**CLASS 1 MODIFICATIONS FOR QUARTER ENDING June 30, 2013**
**Ms. S. L. Dahl-Crumpler, Ecology**

# Hanford Facility RCRA Permit Modification Notification Forms

## Part III, Operating Unit 3

## Liquid Effluent Treatment Facility & 200 Area Effluent Treatment Facility

**Figure 4.2. 242-A Evaporator Process Loop**

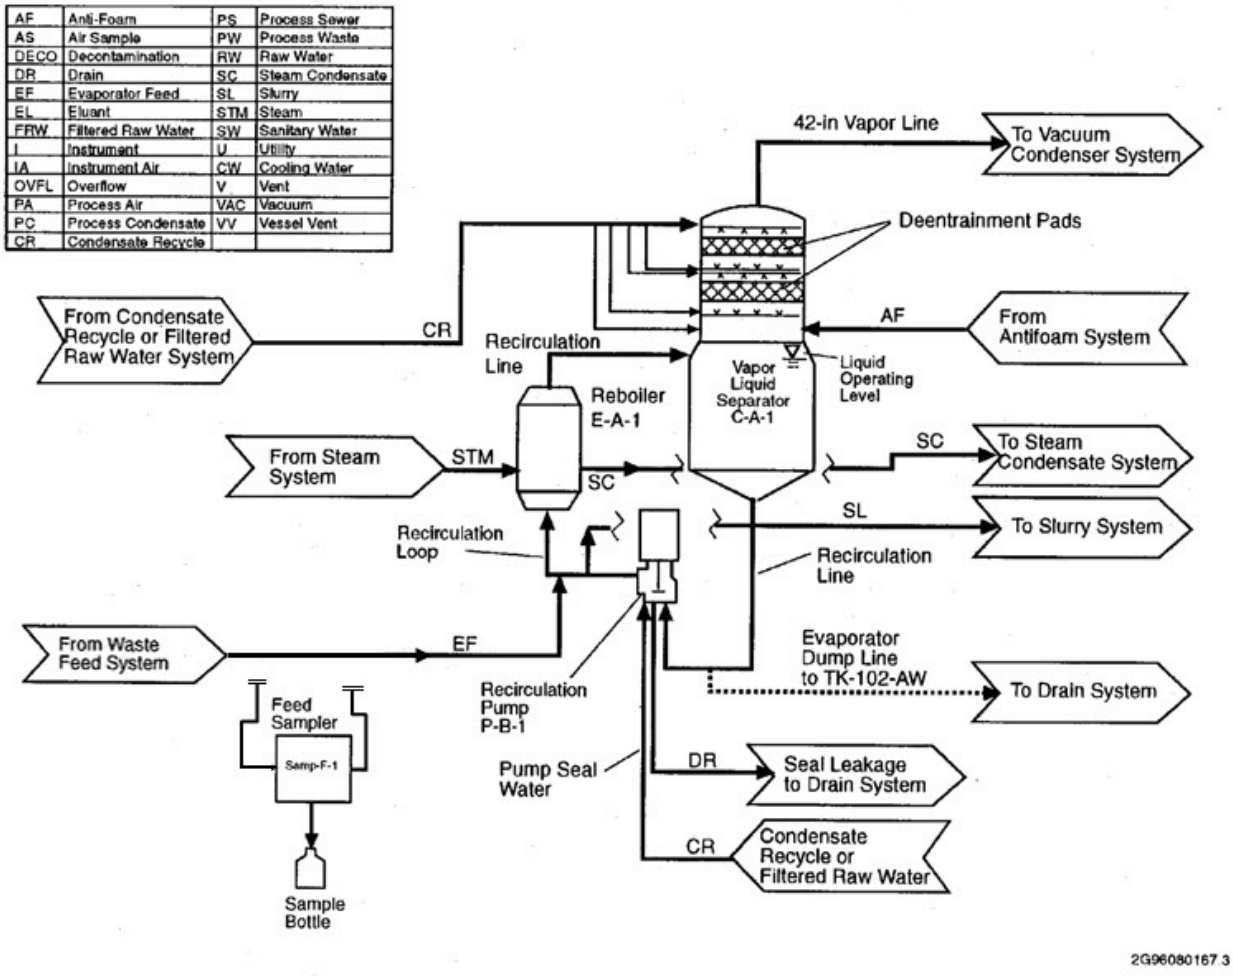
Description of Modification:
Chapter 4.0, Figure 4.2:

Requesting downgrade from Class 3 to Class '1, per WAC 173-303-830(4)(d). Figure 4.2 has been revised regarding the Feed sampler, SAMP-F-1. The figure modification reflects the configuration after the feed sampler has been isolated and blanked.
